**GOVERNMENT ARCHITECT NSW
ADVICE**

St Leonards and Crows Nest 2036 Plan

26 September 2018

Figure 11:
TEST 1

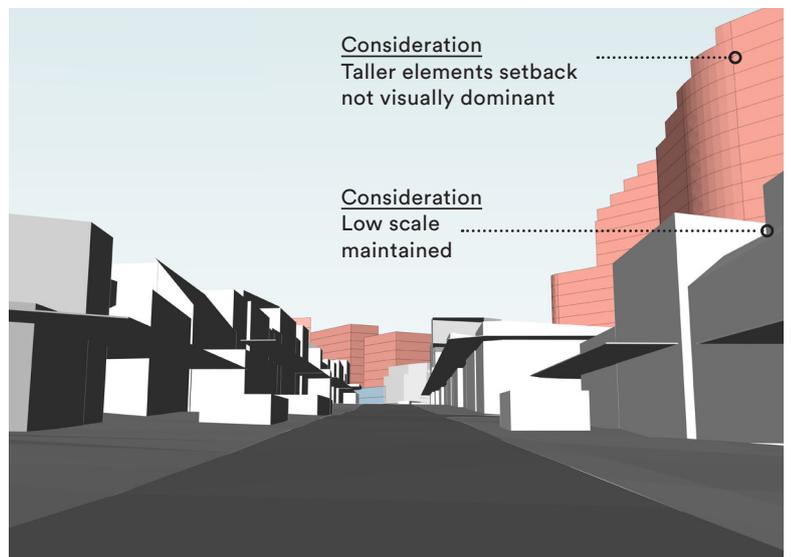
- The lower scale around Willoughby Road is maintained. Taller elements, including those along Clarke Street are visible from Willoughby Road, but set back a significant distance. The street views indicate that the perception of a low-scale environment would be generally maintained. Refer to Figure 14.

Figure 13:
BASE CASE

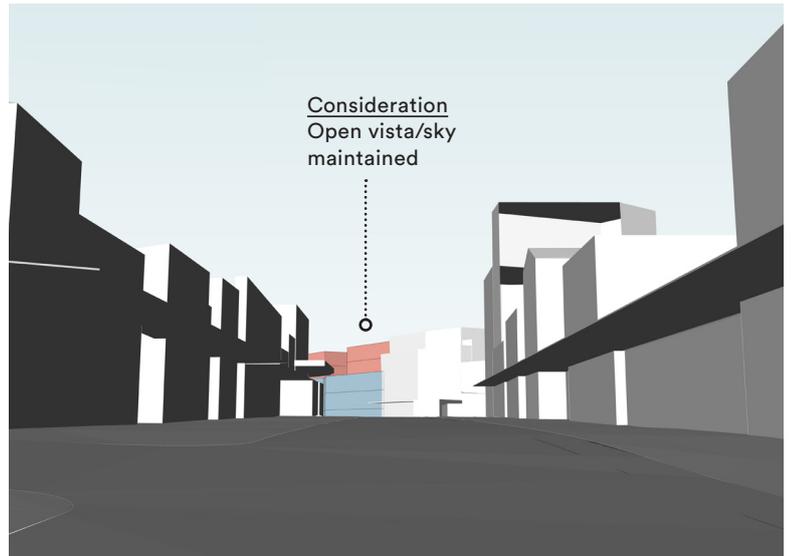
- Low scale in southern portion, such as site-A, is compatible with the varied but prevailing low scale of existing context. **Refer to Figure 10 and 13.**

Figure 16:
BASE CASE

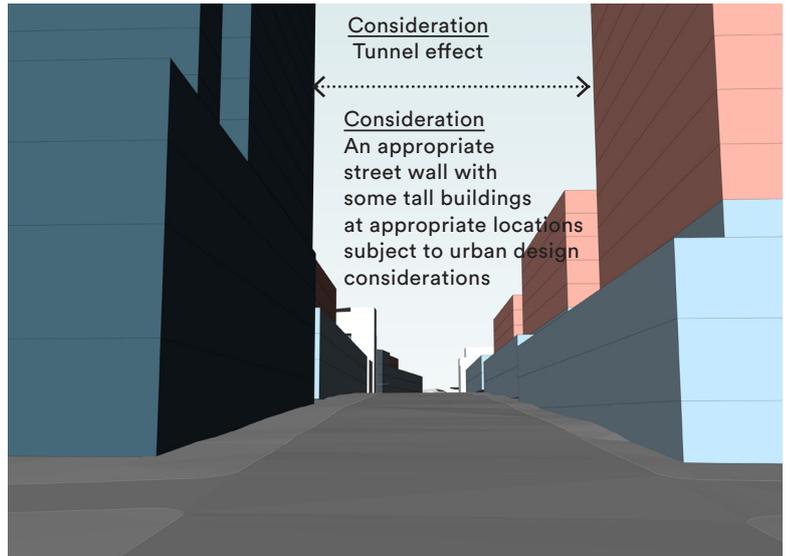
- Significant solar access is maintained to private properties and important places, including Willoughby Road.
- Moderate with some variability in scale along Pacific Hwy may enable a positive pedestrian environment and experience. **Refer to Figure 16.**

Figure 21:
TEST 2

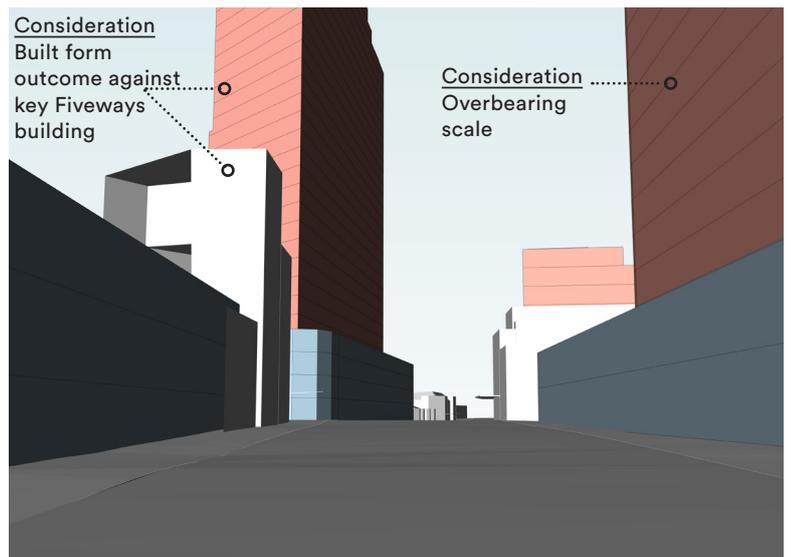
- The nominal building envelope of site-A presents an overly bulky tower form with significant negative visual impacts, in particular when viewed from the low-scale area to the east. **Refer to Figure 21.**

Figure 24:
TEST 2

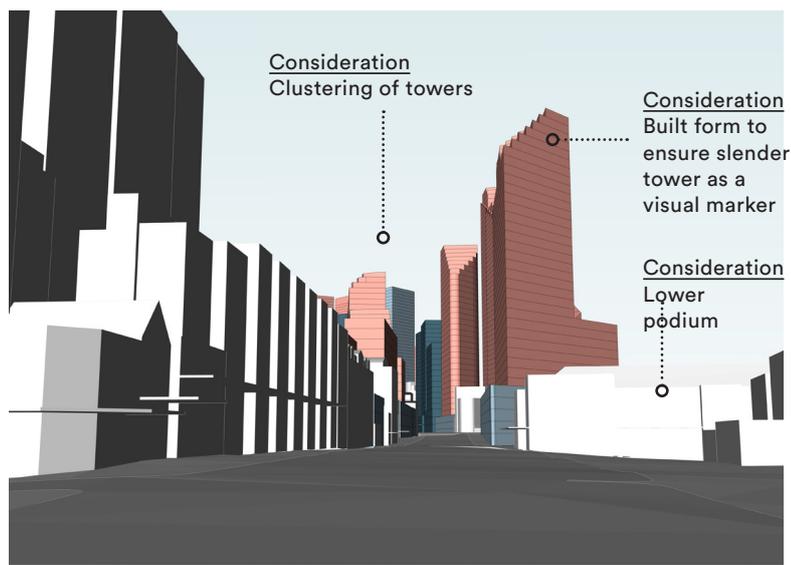
- Site L is in excess of 50 storeys is significantly taller than other buildings in the vicinity. The pedestrian level views indicate that these buildings are visible from key places such as Willoughby Road and likely to be perceived as out of character with the prevailing low-scale and open qualities of the area. **Refer to Figure 24.**

Figure 26:
TEST 1

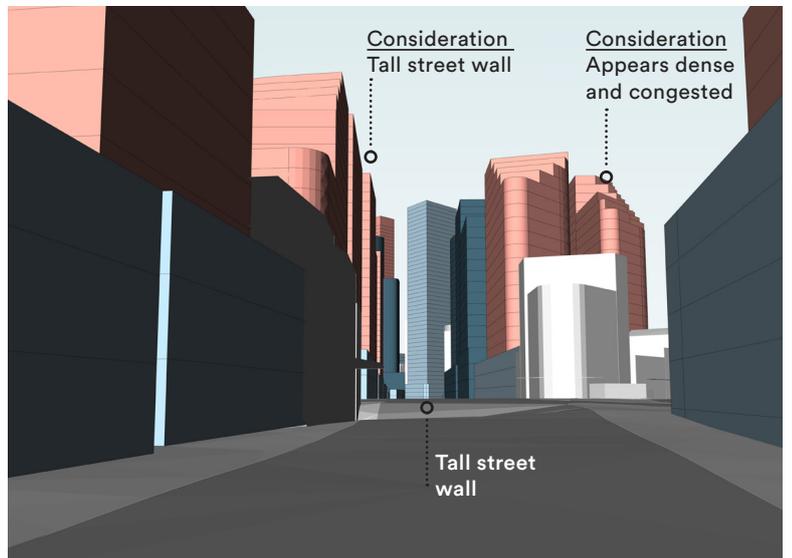
- Modest heights around five-ways provides some additional residential and worker population to support the Willoughby Road ‘high-street’ retail.
- Legible urban form with higher density around metro and Pacific Highway with reduction in scale at edges. **Refer to Figure 26.**
